**SUBJECT: Addendum to Corrective Action Plan
- Oak Walk Redevelopment Site Emeryville, CA**

**ADDENDUM TO
CORRECTIVE ACTION PLAN**

Oak Walk Redevelopment Site
Emeryville, California

3.0 RESPONSE TO TECHNICAL COMMENTS

FIG A-1

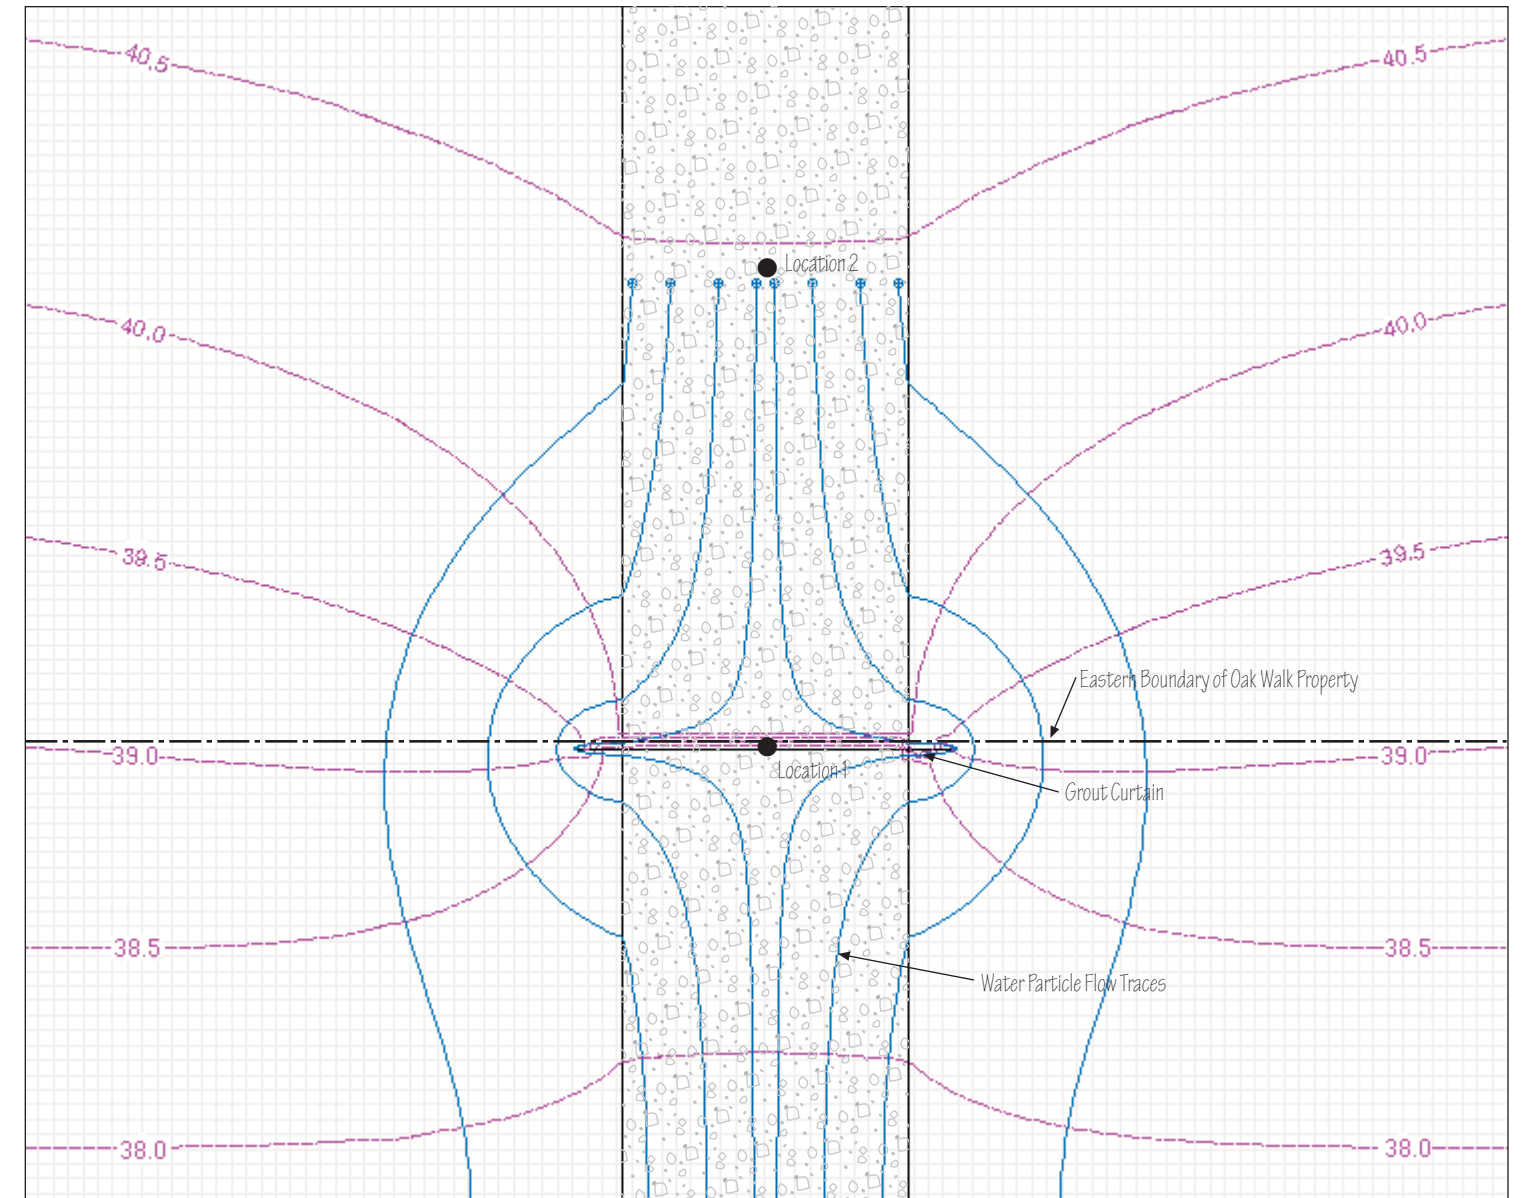
3.1.1 What will be the affect of grout curtains on the subsurface of adjacent properties?

3.1.2 How would the resultant changes in the groundwater flow regime affect the health risks on neighboring properties?

3.1.3 Were other alternatives considered to treat groundwater as opposed to blocking and redirecting it?

Case A on Figure A-1, shows the results of analysis of a simple groundwater flow model consisting of a 30-ft wide sand-filled channel of relatively high permeability cutting

Case B on Figure A-1, shows the results generated by the hydrogeologic model when a curtain wall is installed across the paleo stream bed channel.

Consider the locations labeled Location 1 and Location 2 for Case A on Figure A-1. Location 1 is in the center of the paleo-streambed channel at the location where the grout curtain will be installed. Location 2, also in the center of the paleo-streambed channel, is 50 ft. up-gradient of Location 1. By interpolation between the equipotential lines, the water table elevation at Location 1 is 38.7 ft. above the National Vertical Datum (NAVD) and, at Location 2, the elevation of that water table is 39.5 ft. NAVD. Those elevations are close to those that have actually been observed by SJC and others at the Oak Walk Site.

As is represented in the model for Case B, installation of the grout curtain causes the groundwater elevation at Location 1, which is now immediately up-gradient of the grout curtain, to increase to 40.0 ft. NAVD and at Location 2 to rise to 40.5 NAVD.

The above results predict that the water table immediately to the east of Grout Curtain No.1, which location is on the off-site property adjacent and to the east of the Oak Walk Site, will rise approximately 1.3 ft following installation of the grout curtain. Fifty feet further to the east, which point is also off-site property, the predicted increase in the elevation of the water table is only 1.0 ft. It is estimated that, at a distance of no more than 200 ft. east of the Oak Walk Site boundary, there will be no change in the groundwater table elevation compared to the extant conditions.

The pathways followed by particles of water within the paleo-streambed channel for Case A, when no grout curtain is present are shown on Figure A-1. As would be expected, for simple down-gradient flow in a channel cut through a uniform field of less permeable deposits the flow pathways are unremarkable and simply run parallel to the sides of the channel.

For Case B, which models the conditions after the grout curtain has been installed; the pathways following the same water particles that are traced for Case A I are realigned so that as they flow from east to west they are detoured around the grout curtain. Those water particles that, at the eastern end of the model, are located close to the walls of the paleo-streambed channel are displaced to a maximum distance to the north and south of some 25 ft. However, examination of Figures I-19, I-20 and I-24 in Vol. I of the CAP reveals that the area where the pathway is displaced to the north is beneath 41st Street, where any minor changes in the groundwater regime will be inconsequential. To the south, the pathways are diverted into areas that are currently affected by contaminants flowing westward from the off-site release sites to the east of Adeline Street.

As has been demonstrated in Section 3.1.1.1 above and is shown on Figure A-1, installation of the grout curtains will not “block” or significantly “redirect” groundwater flow. Some water particle flow paths originating upstream of the grout curtains will be forced out of the paleo-streambed channel as they pass around the grout curtain but on its down-gradient side they will again be directed into the stream channel. Some groundwater will, in fact, flow, through the grout curtain, which will not be totally

impermeable ($K_{\text{grout curtain}}$ will be less than 0.0028 ft/day). As can be seen from the Case B modeling result presented on Figure A-1, the groundwater flow paths are shifted only a relatively small distance to the north or south of the streambed channel before they regain their original direction of flow within the paleo-streambed. The beneficial effect of the grout curtain is not that it blocks or redirects all flow but that, by forcing contaminated groundwater to temporarily leave the paleo-streambed channel, groundwater flow velocity is slowed by at least an order of magnitude and there is a very large increase in adsorption of contaminants onto the clayey matrix of the sedimentary deposits through which the channel passes. Taken together, those processes will act to greatly slow the rate of contaminant transport from the up-gradient sources that crosses the Oak Walk site and continues on into the neighborhood to the west of San Pablo Avenue with no significant impact on adjacent properties.

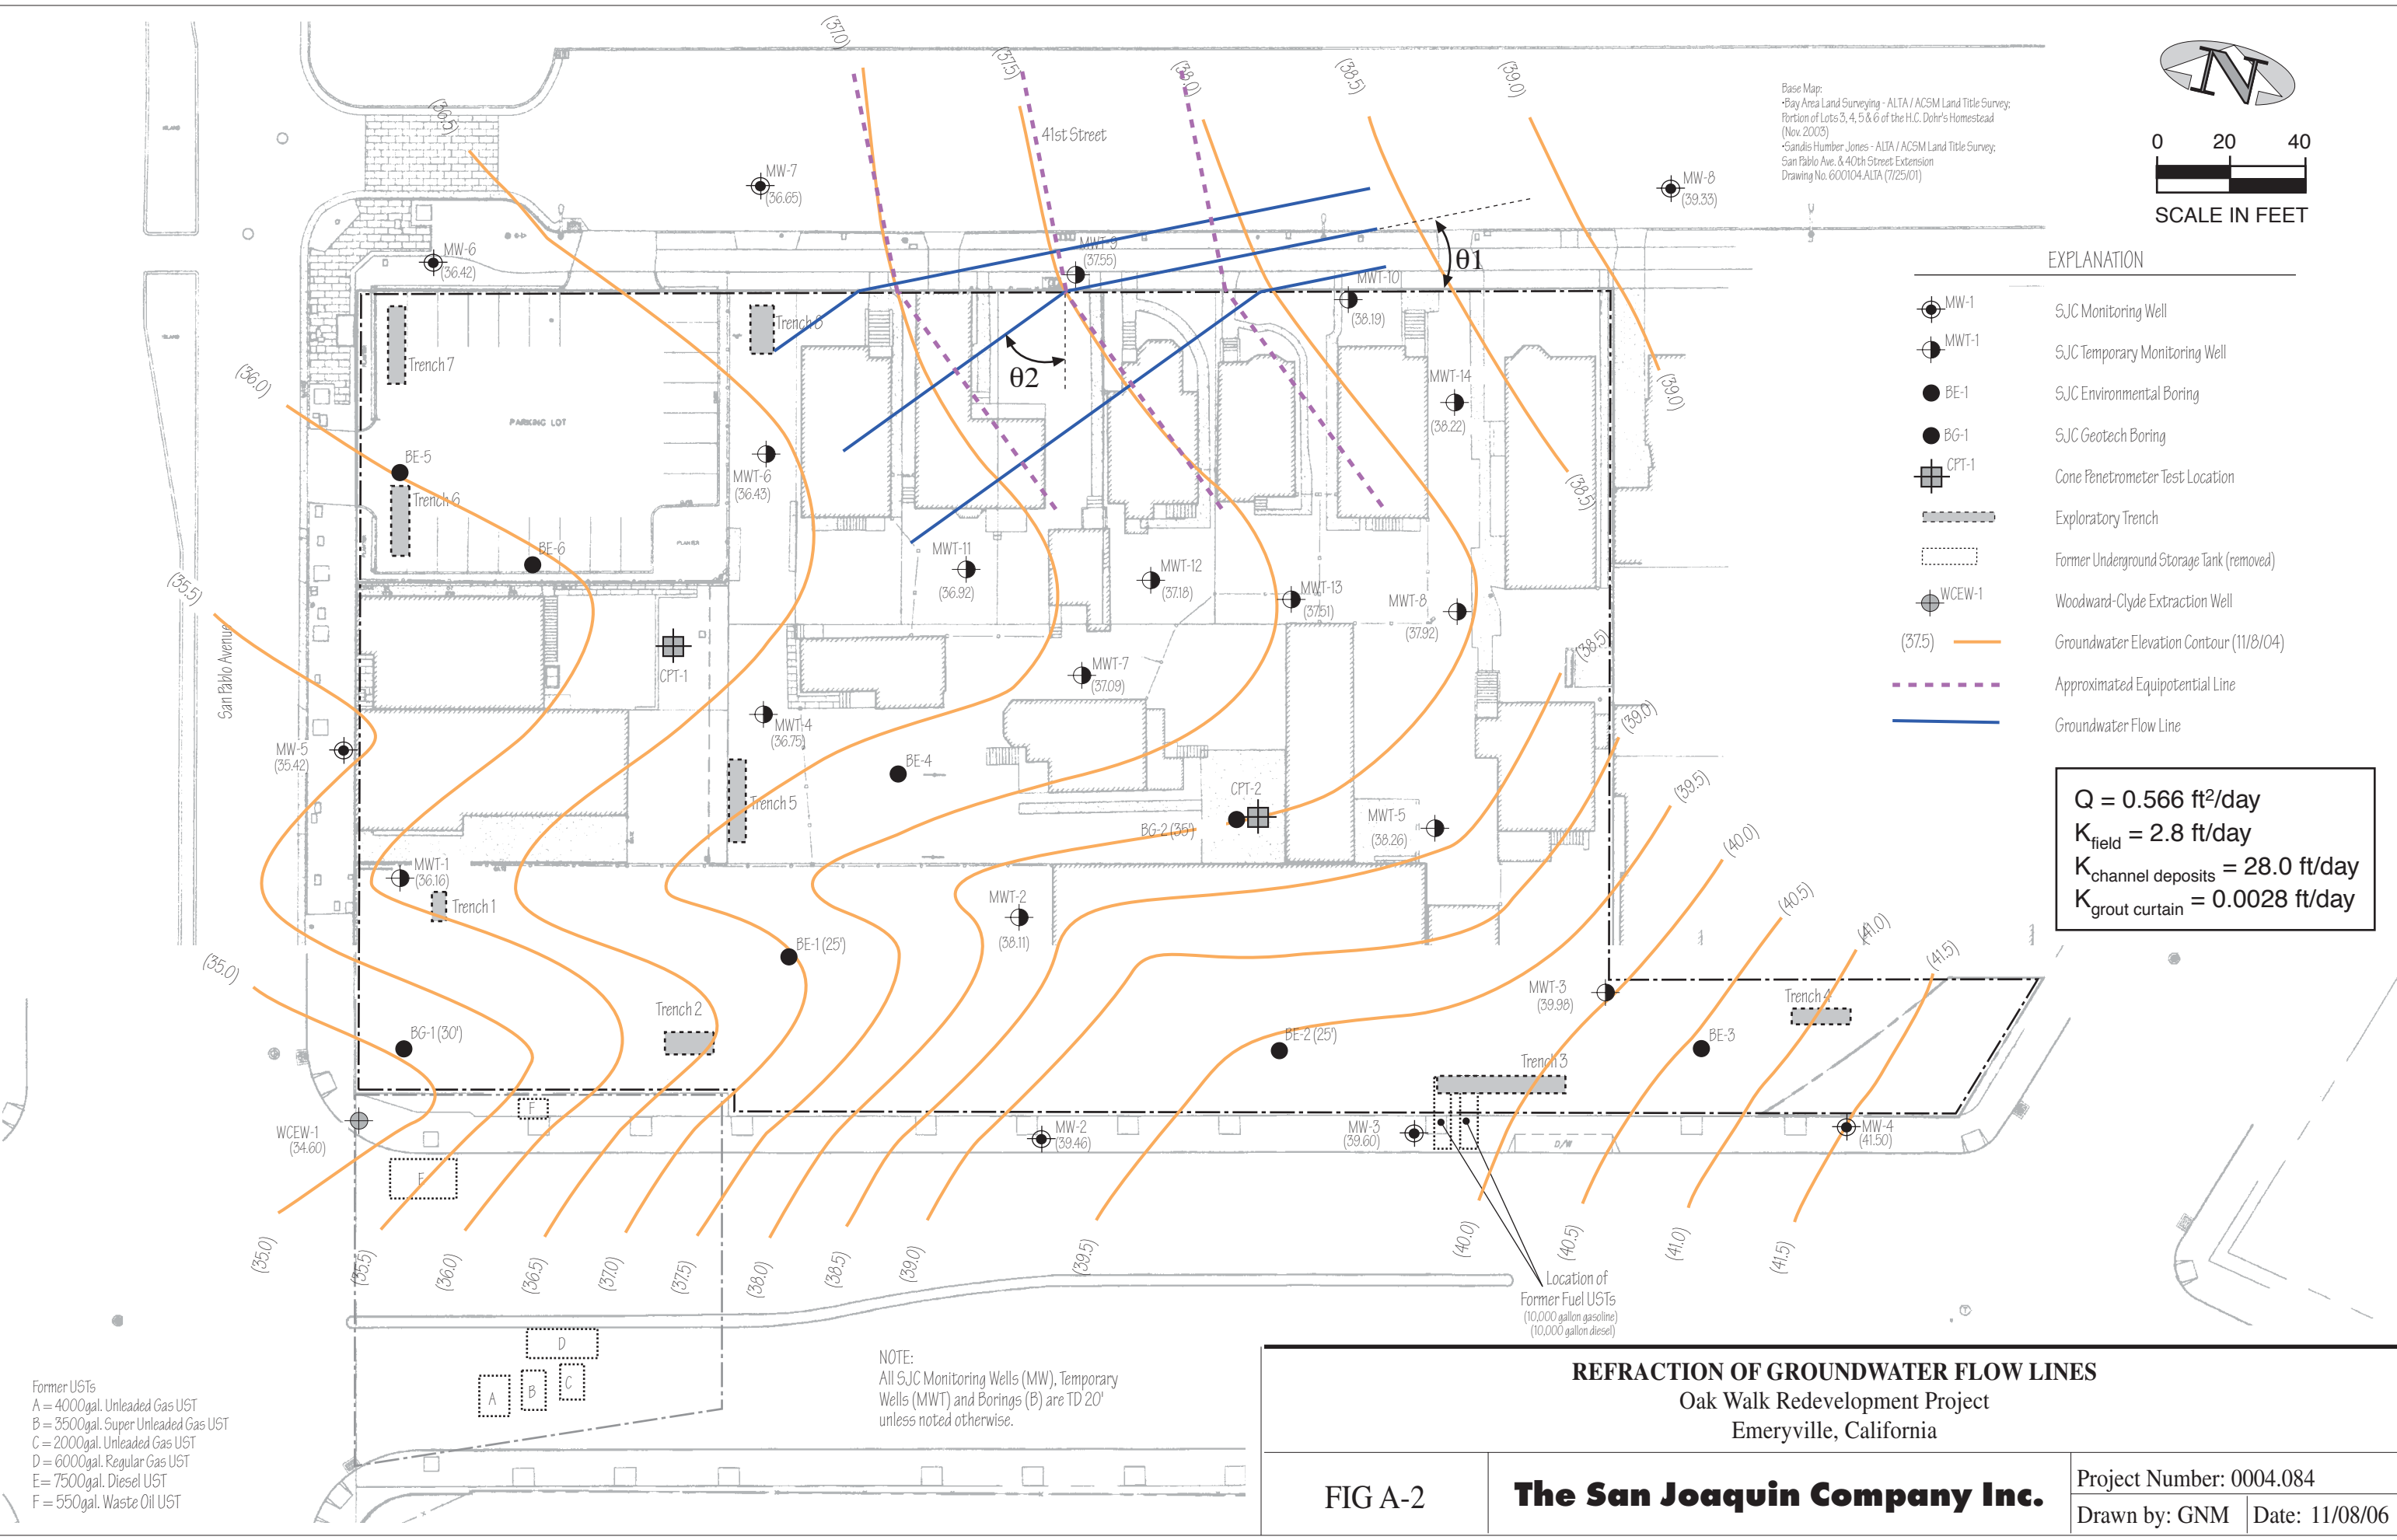
3.4.4 Monitoring of groundwater at former SFFBC tank site

From the local flow line geometry shown on Figure A-2, $\theta_1 = 7.5^\circ$ and $\theta_2 = 39.5^\circ$. Thus, by substitution into Equation 1, an estimate of: $K_{\text{field}} = 0.16 K_{\text{channel deposits}}$ is obtained

The groundwater gradient used in the model of unmodified flow in the paleo-streambed channel (Case A on Figure A-1) was set at 0.0094 ft/ft, as measured from the groundwater contours shown on Figure A-2 that were derived from the measured groundwater elevations on November 8, 2004 in the monitoring well array as reported in Table I-1 of Vol. 1 of the CAP. So that

We also note that, as is evident in the groundwater contours shown in Figure A-2, which is included in this document, the apparent direction of groundwater flow from the former SFFBC tank site is to the west-northwest onto the Oak Walk Site itself. Soil contamination and groundwater quality in the area down-gradient of the SFFBC tanks were investigated by means of borings BE-2 and BG-2 and wells MWT-2 and MW-2, the analytical data from which were presented in Tables I-2 and Table I-4 respectively of Volume 1 of the CAP.
